ROBOKIT

RE-DESIGN BY GROUP 6

## Joint 3

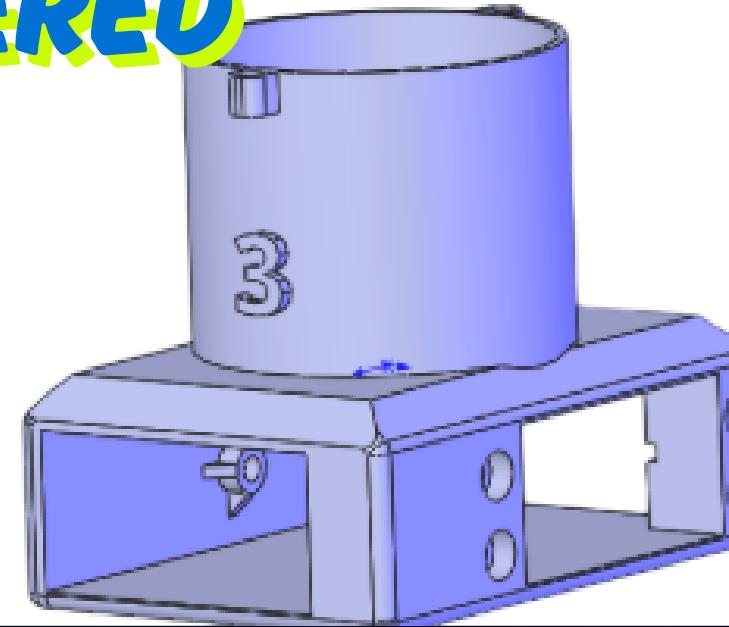
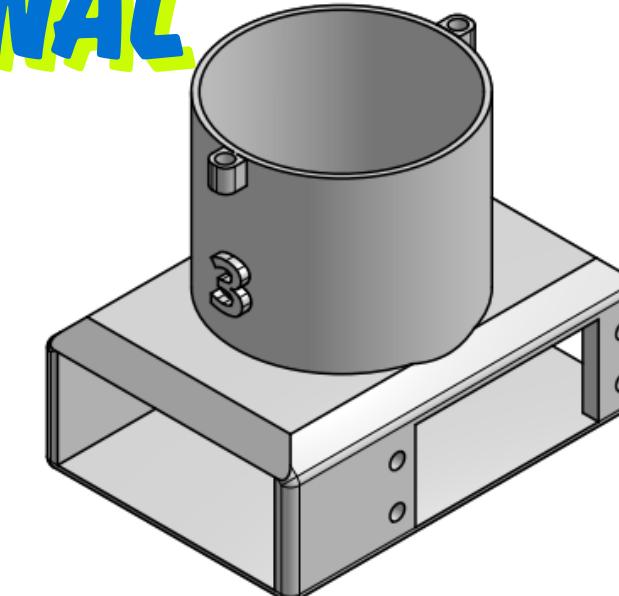
The screw hole has been thickened for added durability, and additional support has been added to the screw hole for the connector, ensuring a more secure and stable assembly when moving. Deeper holes have also been added for the screw to prevent it from sticking out.

## Joint 4

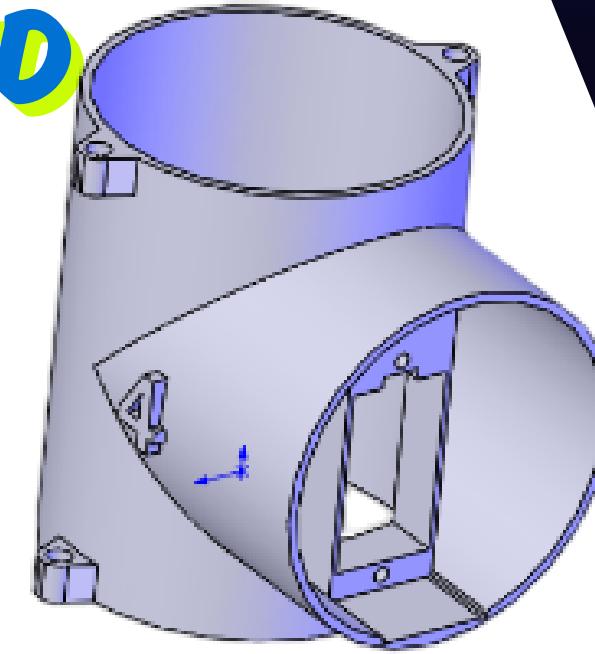
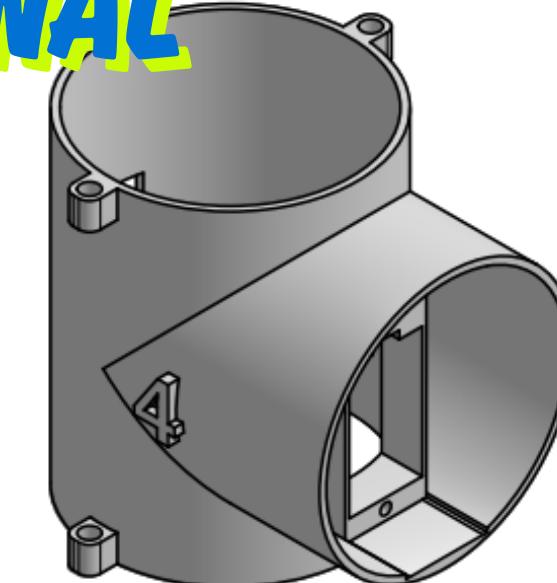
The screw holes has been thickened to prevent breakage during assembly, ensuring greater durability and a more secure fit.

## Joint 5

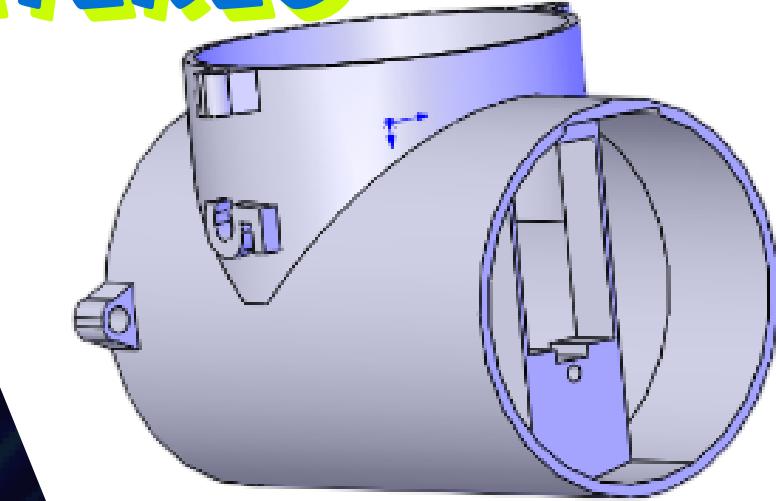
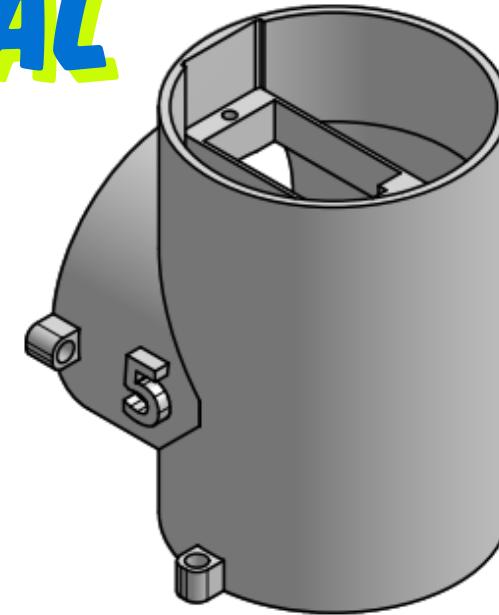
The screw holes have been thickened to enhance durability and prevent breakage during assembly, ensuring a more secure connection.

## Joint 6

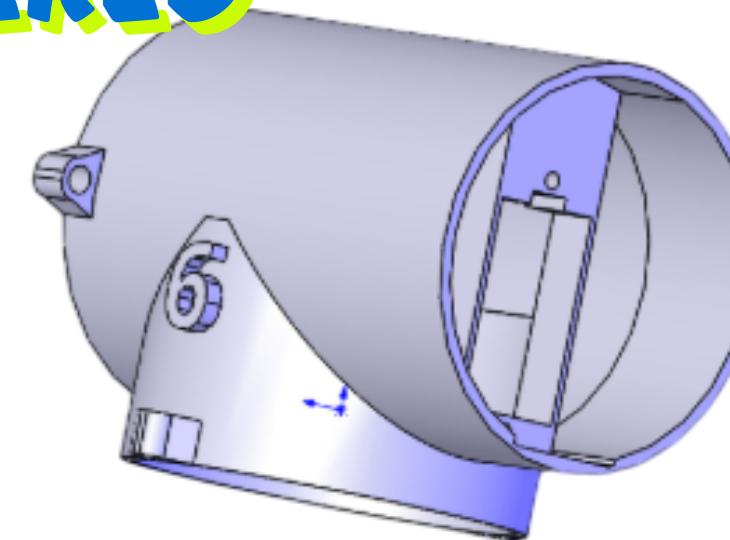
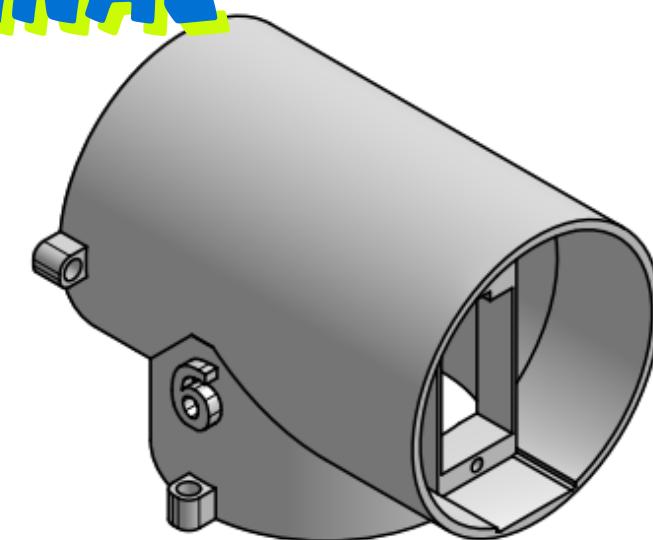
The screw holes have been thickened to enhance durability and prevent breakage during assembly, ensuring a more secure connection.
